To: **Planning Reps**  
From **Highways Development Management Officer**

Your Ref 20240065

Location 11 Long Walk, Istead Rise, Gravesend, Kent DA13 9HH

Drawing DKM/6671/03

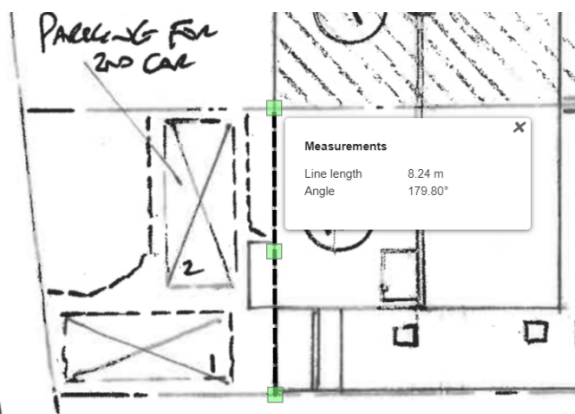
With the changes in informal guidance issued by Kent County Council as Highway Authority the proposed layout for the car parking is acceptable, providing there is a minimum of 1 metre between the parked car and the front door to the property.

Any new driveway should be constructed from a bound permeable material, with no surface water discharging onto the highway or the neighbouring property.
